Colorado Milling Company, LLC File No. M-1994-117 AM-1 Response to 4th Adequacy Review Letter

**RE: Gold Hill Mill, Permit No. M-1994-117, Amendment Application
(Revision No. AM-01), Adequacy Review No. 4**

This is the Colorado Milling Company, LLC's Response Letter to the Amy Eschberger's May 21, 2019 Adequacy Review No. 4 of the Application for an Amendment to the Gold Hill Mill Limited Impact 110 (2) Permit No. M-1994-117, to formally add the previously permitted Left Hand Creek Pump Station, Gold Hill Mill Pipeline, and the Times Mine adit portal to the affected land boundary of the Gold Hill Mill Permit. These three features are collectively referred to as the Gold Hill Mill Waterline in this Response Letter. In order to ensure that the responses to the Division of Reclamation, Mining and Safety's request for additional information and clarification can be properly reviewed, the responses are set out below each of Amy Eschberger's Adequacy Review comments.

MAP E-1A PERMIT BOUNDARIES NEAR LEFT HAND CREEK SHOWING THE WATERLINE INTAKE POINT AND THE PROPOSED FOOTPATH TO ACCESS THE SITE

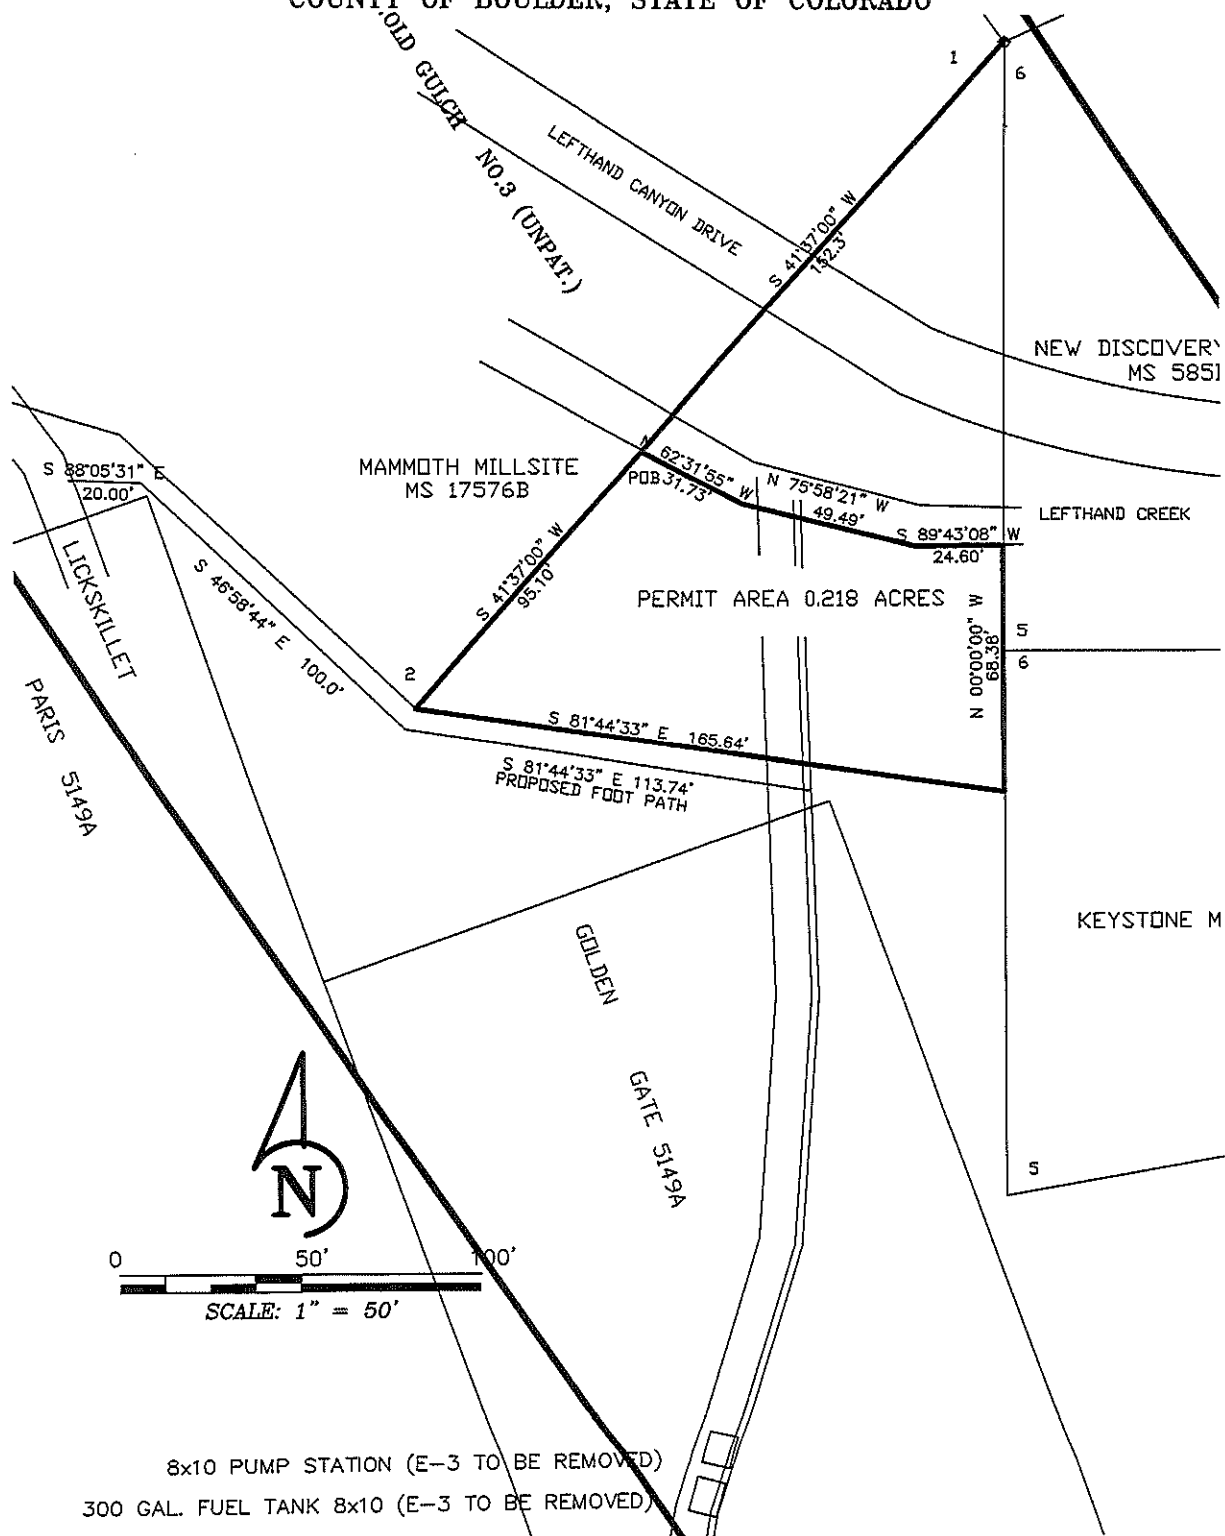
a) A revised Mining Plan Map(s) (Figure E-1) which clearly outlines and labels the permit boundaries described in Exhibit A – Legal Description as required by Rule 6.3.5(2)(a), particularly the permit boundaries proposed near Left Hand Creek.

CMC Response: Attached to this Response Letter are copies of Map E-1A Permit Area of the Permit Boundaries proposed near Left Hand Creek showing where the Pump Station will pump water for the Gold Hill Mill. Also, CMC is attaching a Legal Description of this Permit Parcel with a surveyor's description in metes and bounds for this particular parcel of land. This is essentially the same map of this area that was submitted with CMC's Response Letter to the DRMS's Adequacy Review No. 3, but without as many details to make it easier for the DRMS to accurately identify the affected area which corresponds to the Application for an Amendment to the Gold Hill Mill Permit.

CMC Response: Attached to this Response Letter are copies of Map E-1A Permit Area of the Permit Boundaries proposed near Left Hand Creek showing where the Pump Station will pump water for the Gold Hill Mill. Also, CMC is attaching a Legal Description of this Permit Parcel with a surveyor's description in metes and bounds for this particular parcel of land. This is essentially the same map of this area that was submitted with CMC's Response Letter to the DRMS's Adequacy Review No. 3, but without as many details to make it easier for the DRMS to accurately identify the affected area which corresponds to the Application for an Amendment to the Gold Hill Mill Permit.
